Project	IEEE 802.16 Broadband Wireless Access Working Group http://ieee802.org/16 >
Title	Ambiguity in PHY layer §8.3 OFDM frequency and timing requirements
Date Submitted	2005-03-16
Source(s)	Juergen Otterbach Joerg Schaepperle Roland Muenzner Torsten Fahldieck Alcatel SEL AG Voice: +49-711-821-32255 Fax: +49-711-821-32453 Juergen.Otterbach@alcatel.de
Re:	Response to call for comments IEEE P802.16-2004/Cor1-D1
Abstract	Correction of inconsistencies for 802.16-2004 PHY §8.3 OFDM
Purpose	Resolving ambiguity in PHY layer §8.3 OFDM
Notice	This document has been prepared to assist IEEE 802.16. It is offered as a basis for discussion and is not binding on the contributing individual(s) or organization(s). The material in this document is subject to change in form and content after further study. The contributor(s) reserve(s) the right to add, amend or withdraw material contained herein.
Release	The contributor grants a free, irrevocable license to the IEEE to incorporate material contained in this contribution, and any modifications thereof, in the creation of an IEEE Standards publication; to copyright in the IEEE's name any IEEE Standards publication even though it may include portion

Figure 1: Possible differences in OFDM symbol duration

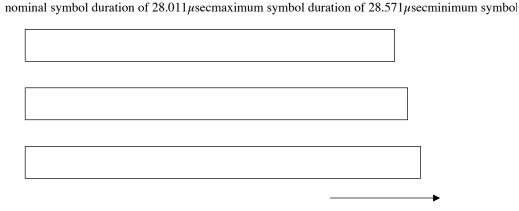
According to this tolerance the SS is allowed to transmit OFDM symbols with differences in duration as shown in Figure 1 with a Cyclic Prefix (CP) time of 1/4 of the "useful" symbol time assumed. The symbol time extension by the CP is 256/4 = 64 samples. The whole symbol is equivalent to 320 samples that correspond to symbol time $T_s = 28.011\mu$ sec nominal.

In a view of the Base Station receiver a nominal symbol duration of 28.011μ sec is expected. An UL OFDM symbol with maximum symbol duration of 28.571μ sec is 6.4 samples longer than the expected nominal symbol duration of 28.011μ sec. A detection of the short preamble using time domain correlator principles would fail.

Moreover the term "locked" is ambiguous, making it unclear whether the term "synchronized" applies to the synchronization of the SS to the BS or to the synchronization between the symbol clock frequency and the center frequency at the SS.

The above ambiguity could be solved by explicitly stating that the accuracy of the symbol clock frequency at the SS is guaranteed by its locking to center frequency at the SS, thereby exploiting the fact that through the requirement, that the symbol clock frequency and the center frequency are derived from a single reference at the BS, they have a fixed and predefined ratio.

At the SS, both the transmitted center frequency and the symbol clock frequency shall be synchronized and locked to the BS with a tolerance of maximum 2% of the subcarrier spacing and the symbol clock frequency of the SS shall be synchronized to the symbol clock frequency of the BS with a tolerance of maximum $0.02 \times (\text{subcarrier spacing}) \times (\text{symbol clock frequency}) / (\text{center frequency})$.
